ST. LUCIE PLANT UNIT NO. 1

Amendment No. 77 License No. DPR-67

ATTACHMENT TO LICENSE AMENDMENT NO. 77

SAFETY EVALUATION BY THE OFFICE OF NUCLEAR REACTOR REGULATION

FIGURE 3.2-2

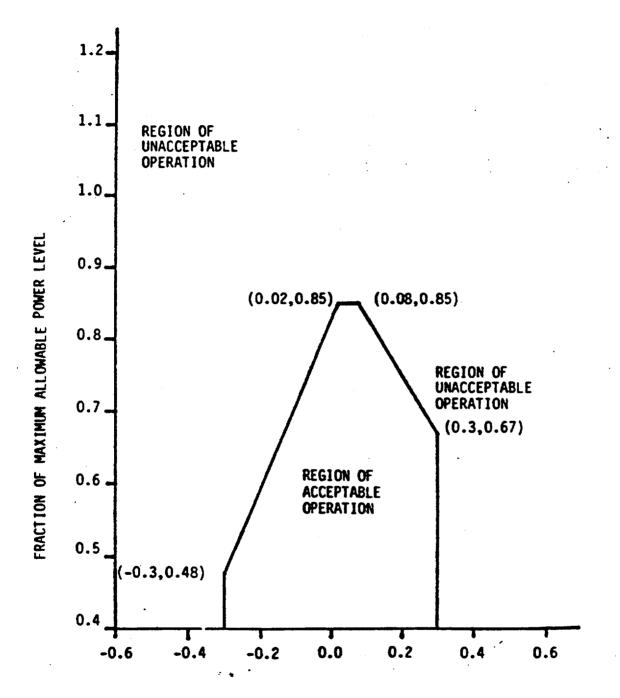
This amendment lowers the maximum allowable power level for linear heat rate monitoring using the excore detector system from 88 percent to 85 percent when the peripheral axial shape index is between 0.02 and 0.08.

By letter L-86-510 dated December 18, 1986, Florida Power and Light Company (FPL) submitted a request to decrease the maximum allowable power level from 0.88 to 0.85 in Figure 3.2-2, "Axial Shape Index Versus Maximum Allowable Power Level Per Specification 4.2.1.3" of the St. Lucie Unit 1 Technical Specifications. This proposed reduction in maximum allowable power level has been made to accommodate the potential for more restrictive axial power shapes in future Unit 1 fuel cycles.

The proposed Figure 3.2-2 has been made more restrictive by decreasing the maximum allowable power level fraction from 0.88 to 0.85. Operation under the proposed Figure 3.2-2 meets all the NRC acceptance criteria stated in Chapter 15 of the Standard Review Plan. In addition, these analyses were performed with assumptions and methodology which have been approved by the NRC. Therefore, the staff finds the proposed change acceptable.

The staff has reviewed the proposed change to Figure 3.2-2 of the St. Lucie Unit 1 Technical Specifications. Based on the above safety evaluation, the change is acceptable.
